April 29, 1997

REVIEW OF THE DRAFT SUPPLEMENT TO THE WIPP ENVIRONMENTAL IMPACT STATEMENT DOE/EIS-0026-S-2

April 1997

EEG-64
DOE/AL58309-64

Figure 1. Proven and Probable Hydrocarbon Reserves for Brushy Canyon (after Broadhead et al, 1995, as published in EEG-62).

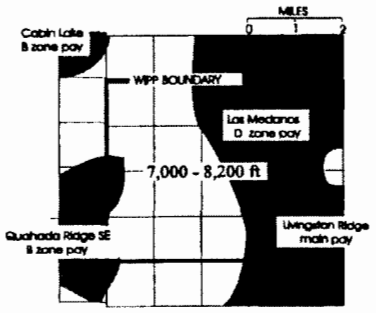
Hydrocarbon resource is a very important issue and merits much more than a cursory overview by three short paragraphs.

The SEIS should have at least a series of maps showing proven and probable reserves at the various reservoir depths (eg. Figure 1), an illustration of the geologic cross section of the area resources and current production (eg. Figure 2), and a current map indicating drilling interest in the area and the extent of drilling delayed due to the presence of potash (eg. Figure 3). See EEG-62 (Silva, 1996) for a discussion of these figures.

Figure 4. Estimated areal extent of potash reserves.

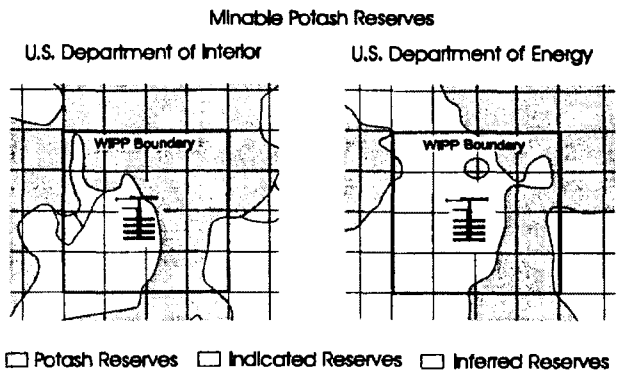
This section should have maps showing the extent of lease grade potash reserves including the extent of potash reserves under the WIPP Site. Further, the SEIS should rely on the official position of the Department of Interior. The text should then discuss the maps and the impact of WIPP on the potash industry and the potential impact of potash mining on the WIPP based on potash reserve estimates by the Department of Interior.

Figure 5. Actual growth of oil production.

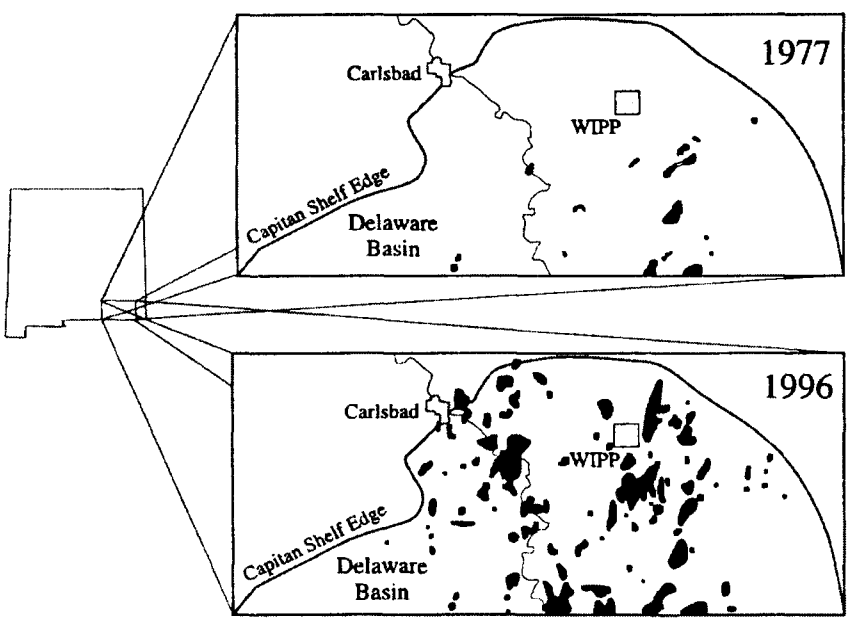
The increase in oil and gas drilling activities, shown in Figure 5, continues to put demands on the need for brine supplies in the areas of new drilling.

Figure 6. Solution mining of the Salado Formation.

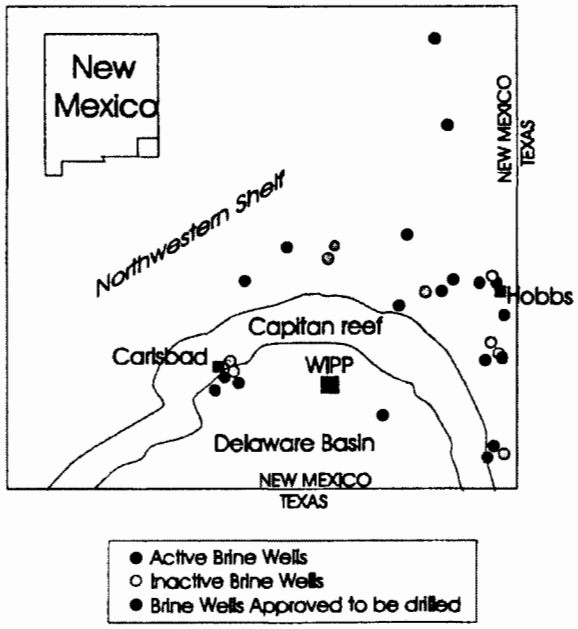
There needs to be a section discussing the decades long activity of solution mining of halite, shown in Figure 6, from the Salado Formation to produce brine for drilling oil and gas wells throughout southeast New Mexico.

Figure 7. Postulated correlation between oilfield salt water injection and water level rises.

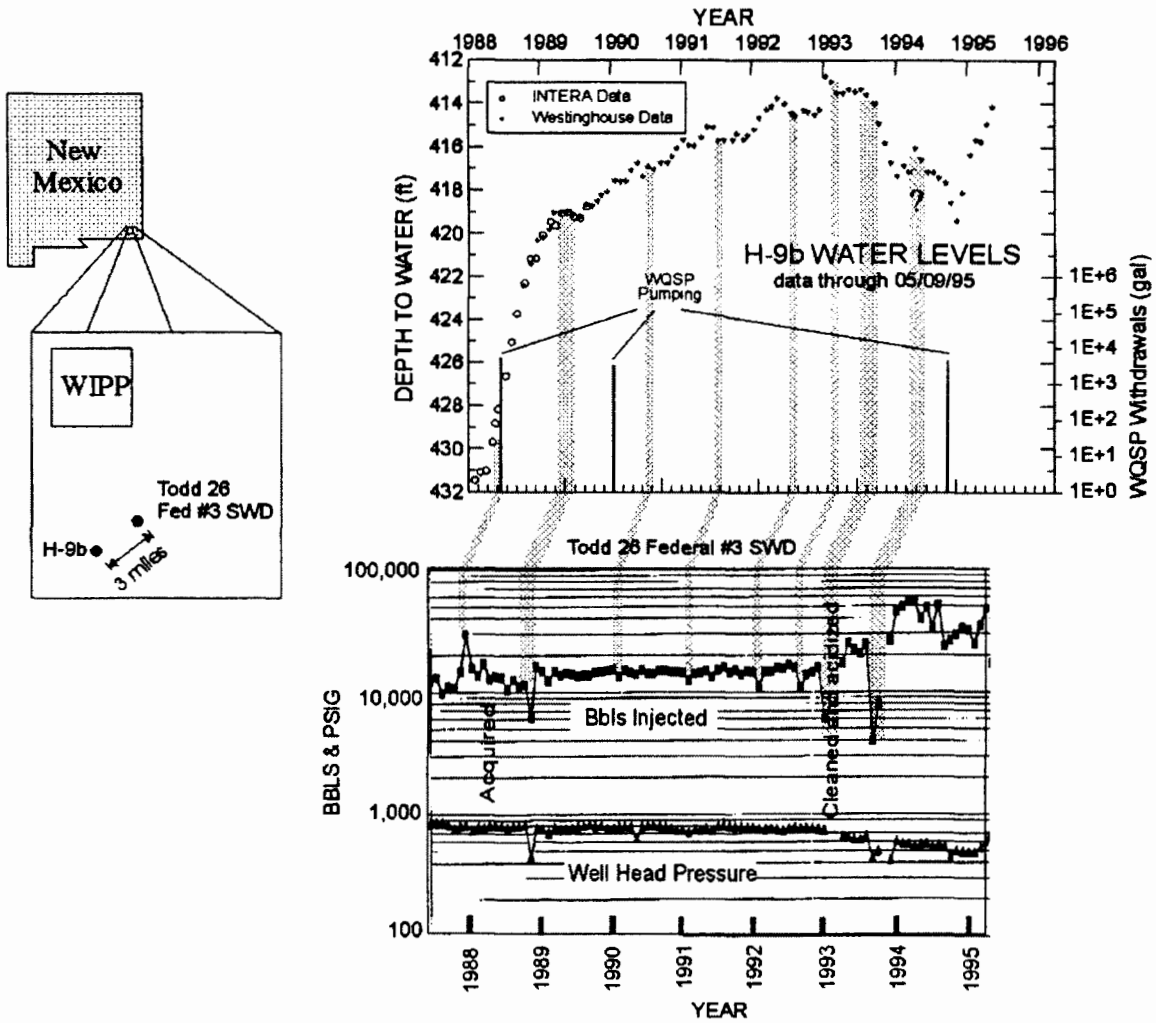
Page 4-21.
The discussion of the water level rises in the Culebra Aquifer and the potential impact of salt water disposal wells would be clearer by preparing and presenting a figure such as the one shown here and published in EEG-62.
